PILGRIM NUCLEAR POWER STATION UNIT 1

Amendment No. 6  
License No. DPR-35

CHANGE NO. 8 TO THE TECHNICAL SPECIFICATIONS

SAFETY EVALUATION BY THE DIRECTORATE OF LICENSING  
SUPPORTING AMENDMENT NO. 6 TO LICENSE NO. DPR-35  
(CHANGE NO. 8 TO THE TECHNICAL SPECIFICATIONS)  
BOSTON EDISON COMPANY  
PILGRIM NUCLEAR POWER STATION, UNIT 1  
DOCKET NO. 50-293

APRM SCRAM AND ROD BLOCK TRIP LIMITING SAFETY SYSTEM SETTINGS  
FIG. 2.1.1

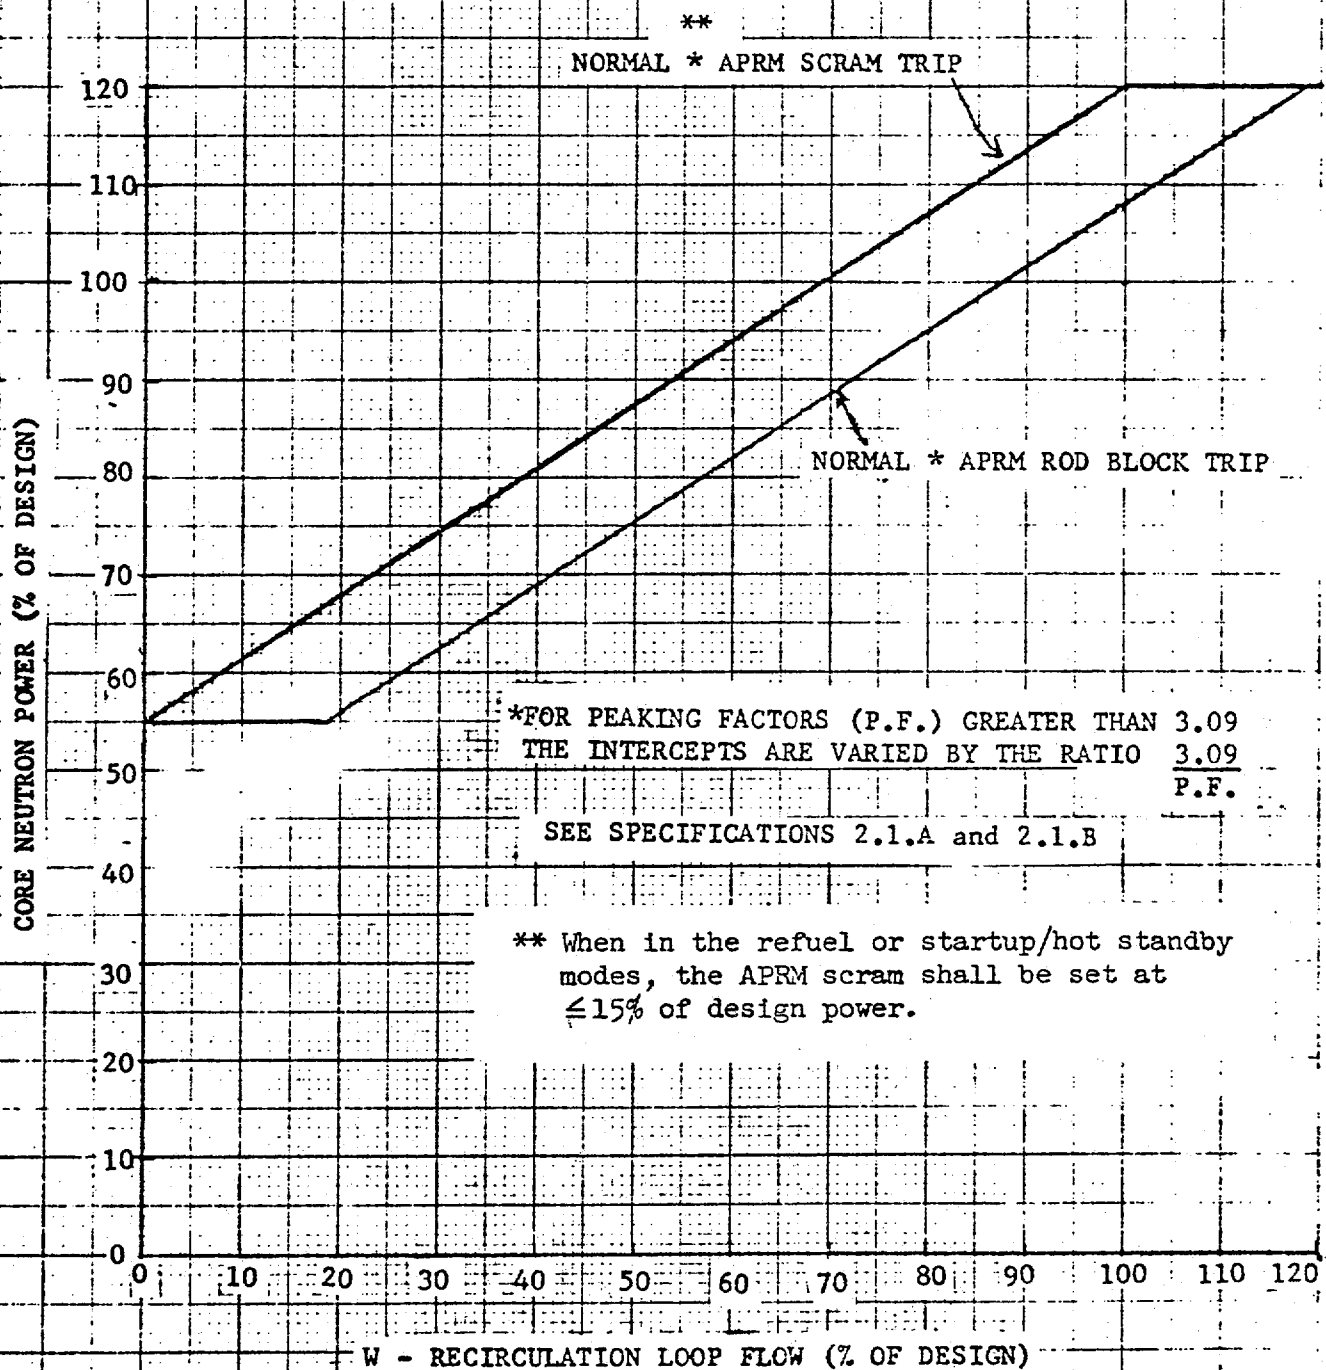
The APRM Control Rod Block trip set point(s) shall be biased with flow as shown on Fig. 2.1.1 and shall be less than or equal to:

$$S \leq \left[ .65W + 43 \right] \left[ \frac{3.09}{P.F.} \right]$$

FIGURE 6.1.1 BOSTON EDISON COMPANY LINE ORGANIZATION

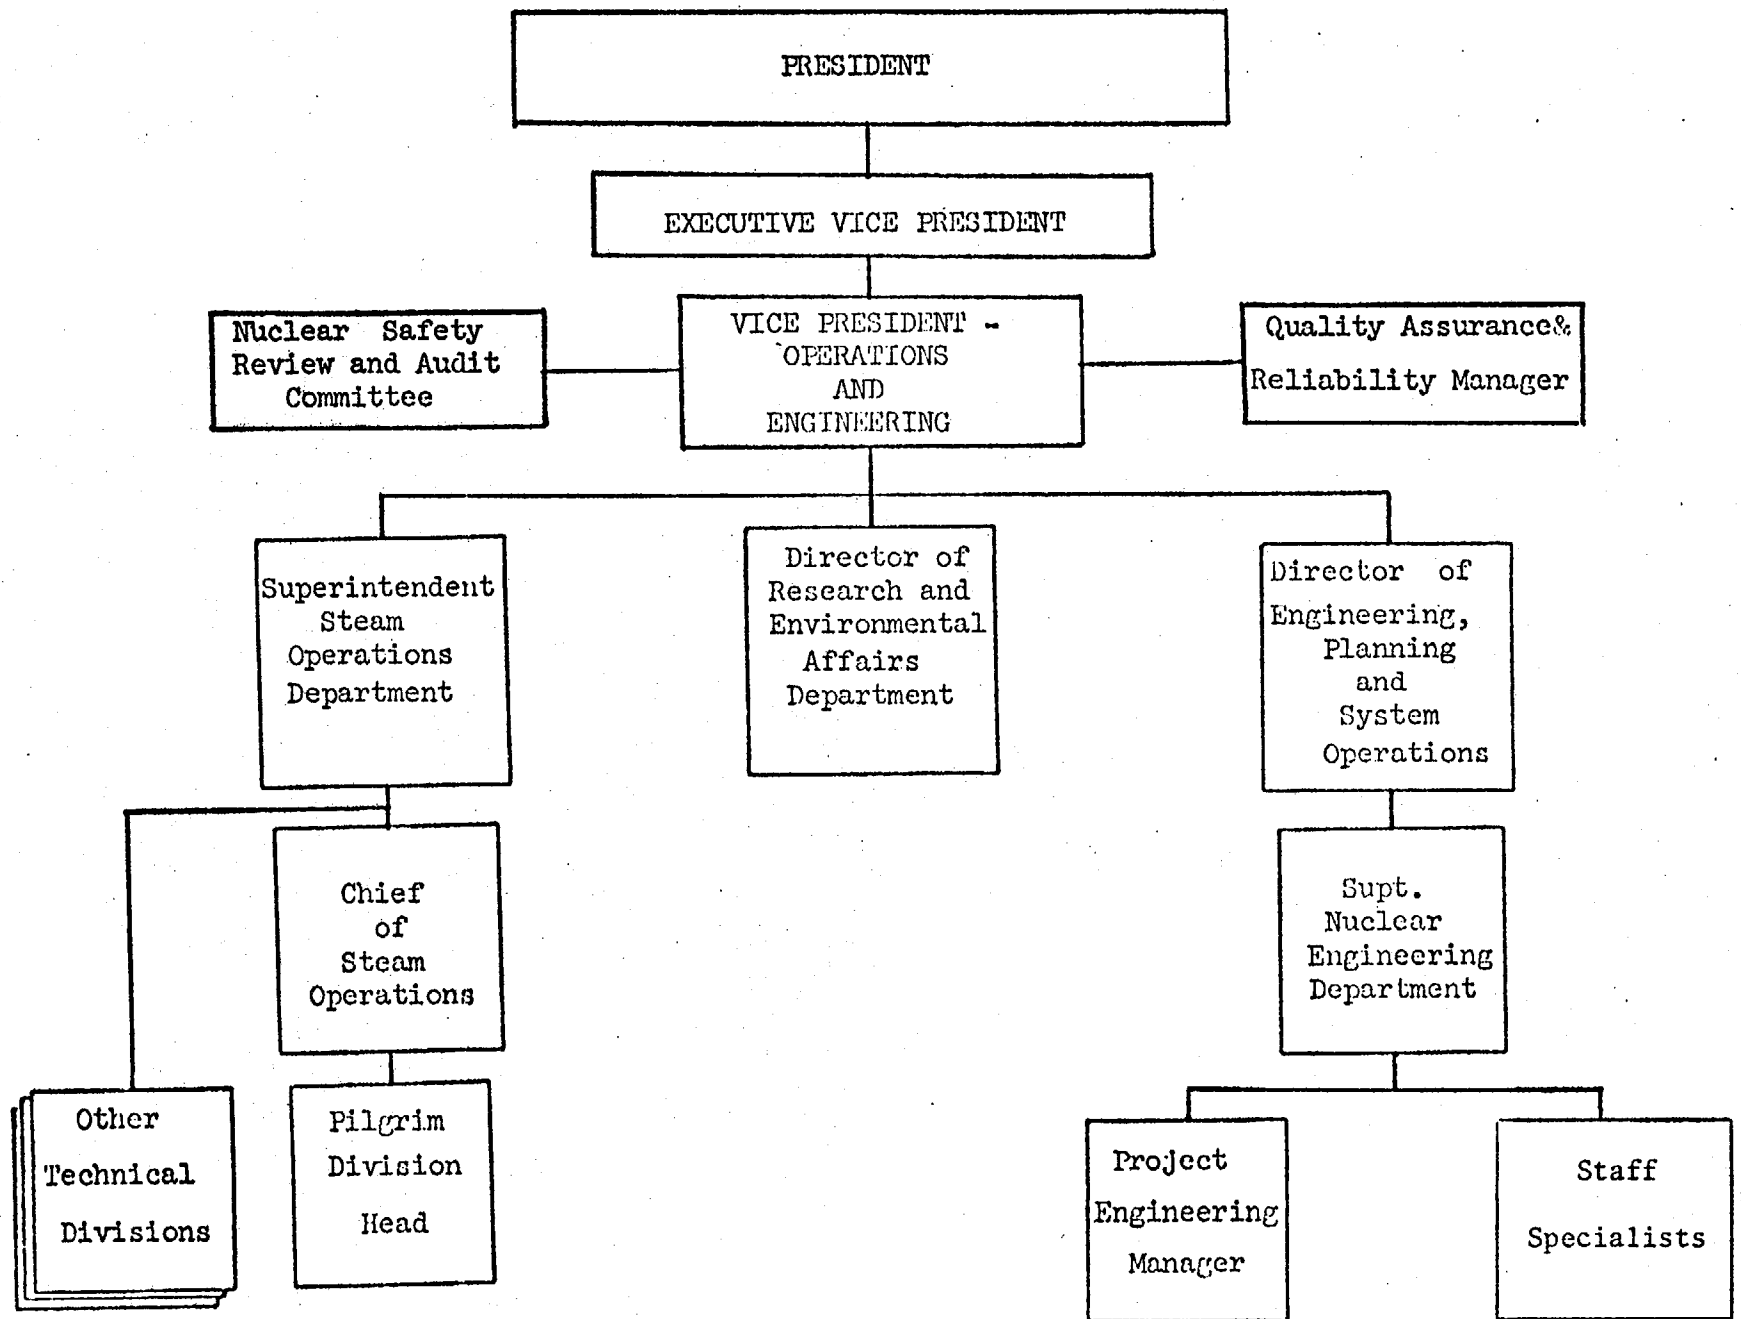
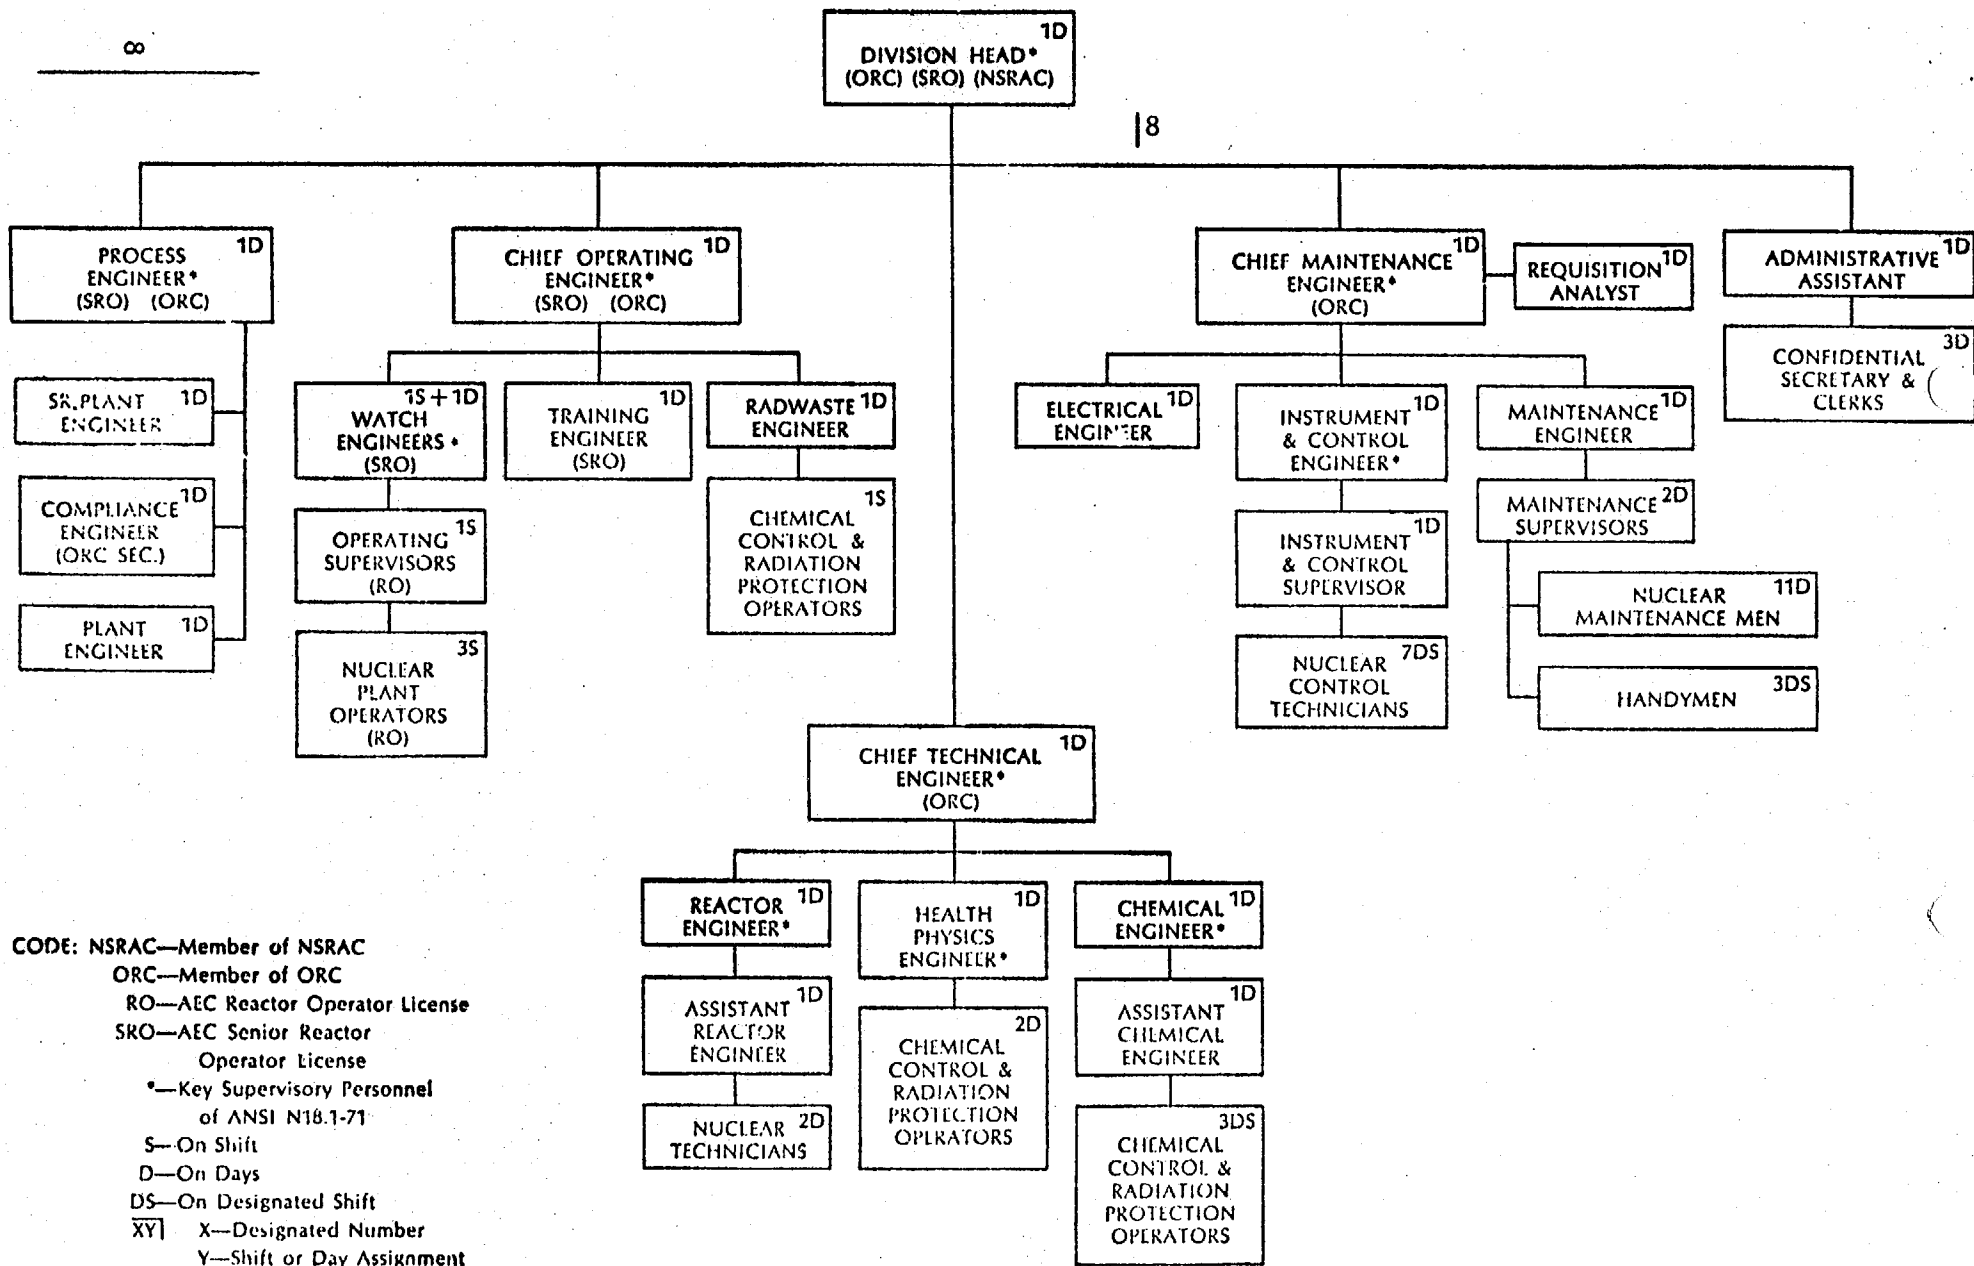
By letter dated June 18, 1973, BECO described a revision to their company line organization as previously shown in Figure 6.1.1 of the Technical Specifications. This letter also requested certain changes in the responsibilities and records of the Nuclear Safety Review and Audit Committee (NSRAC) to recognize the described organizational change. Responsibilities for review and reporting remain undiminished.

By letter dated April 8, 1974, BECO notified the Commission of the establishment of a Senior Plant Engineer position reporting to the Process Engineer. This position was established to improve certain administrative work within the station staff.

We have reviewed the changes to the organization as described in these two letters and find them consistent with our requirements for corporate support of licensed nuclear facilities and station staffing. Our review concluded that these organization changes do not result in any loss of authority or diminishment of responsibilities relative to the safe operation of the plant. Therefore, we find the organizational changes acceptable. These organizational changes result in revisions to pages 208, 209, 210, 212, and 213 of the Technical Specifications as marked in the attachment to the license amendment.
